Access Compliance Report

Public Rights-of-Way

(Curb Ramps)

Intersection ID: 52476	Main Street: WHITEHALL_EXECUTIVE_CENTER_DR	Cross Street: CERNAL_DR	Location: SE
ADA ID: B1DD87EC4E7B	Ramp Type: Perp	Initial Pass/Fail: Fail	Overall Compliance: No
Severity Score: 12.5			
Codes/Mitigation Info/Possible Solution		Field Measurements/Component Compliance

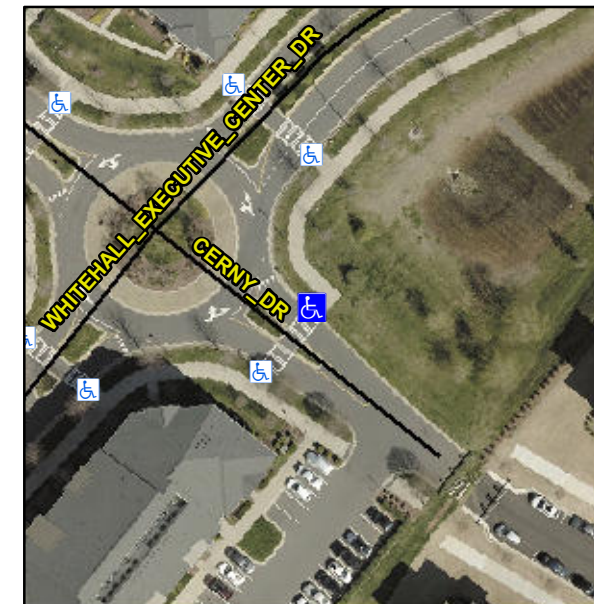
R304.2.2

Compliance	Description	Data	Compliance	Description	Data
N/A	Ramp Length (in)	94.0	No	Ramp Slope (%)	8.7
Yes	Ramp Width (in)	97.0	Yes	Ramp XSlope (%)	1.4
N/A	Flare Type LT	N/A	N/A	Flare Type RT	N/A
N/A	Flare Slope LT (%)	N/A	N/A	Flare Slope RT (%)	N/A
N/A	Flare Traversable LT?	N/A	N/A	Flare Traversable RT?	N/A
N/A	Landing Length (in)	N/A	N/A	DWS Provided?	N/A
N/A	Landing Width (in)	N/A	N/A	DWS Contrast?	N/A
N/A	Landing Slope (%)	N/A	N/A	DWS Length (in)	N/A
N/A	Landing X Slope (%)	N/A	N/A	DWS Full Width?	N/A
N/A	Landing Curb? (Y/N)	N/A	N/A	DWS Offset (in)	N/A
N/A	Shared Landing?	N/A			
N/A	Gutter Ponding?	N/A	N/A	Gutter Slope (%)	N/A
N/A	Gutter Lip Ht (in)	N/A	N/A	Gutter X Slope (%)	N/A
N/A	Painted X Walk1?	Yes	N/A	Painted X Walk2?	N/A
	X Walk 1 Direction	To SW		X Walk 2 Direction	N/A
N/A	X Walk 1 Width (in)	112.0	N/A	X Walk 2 Width (in)	N/A
	X Walk 1 Slope (%)	1.7		X Walk 2 Slope (%)	N/A
	X Walk 1 X Slope (%)	2.0		X Walk 2 X Slope (%)	N/A

Remove & Replace Entire Ramp.
